Minutes – Executive Policy Committee – February 9, 2005

Minute No. 162 Plan Winnipeg Amendment: Concordia Avenue Alignment
File EP-1.1 (PW 5/2004)

Re: PLAN WINNIPEG AMENDMENT: CONCORDIA AVENUE ALIGNMENT

Report date: January 25, 2005

ATTACHMENT A: DRAFT BY-LAW

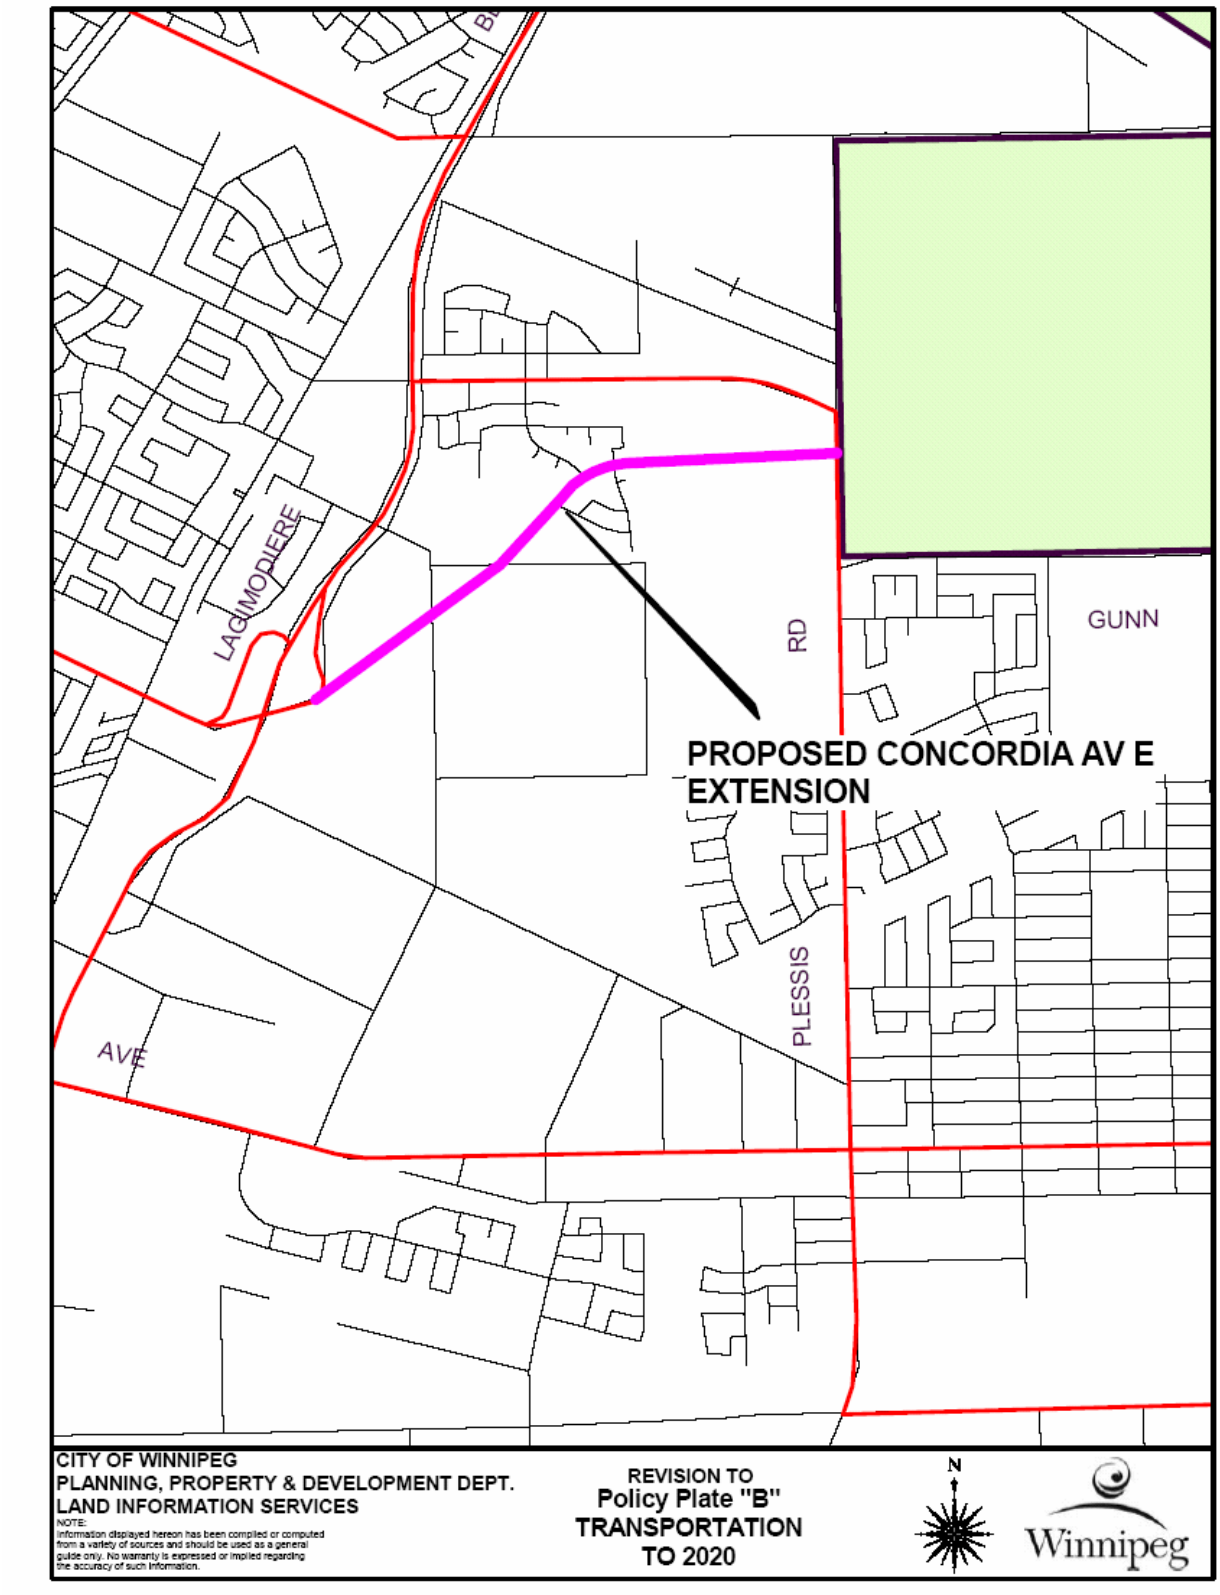
1. The map titled "POLICY PLATE B, TRANSPORTATION, PLAN WINNIPEG 2020 VISION", attached to and forming part of By-law No. 7630/2000 is hereby amended as follows:

"Lands known as the "Concordia Avenue Extension" located in the East Kildonan – Transcona Community of The City of Winnipeg, shown outlined on the map below and generally described as being situated adjacent to the CPR Keewatin Right-of-Way between Lagimodiere Blvd. to the west and Plessis Avenue to the east are hereby amended for the purpose of route realignment and the said Plan Winnipeg Policy Area Map shall hereafter be read and construed as though the said lands were indicated thereon as amended."
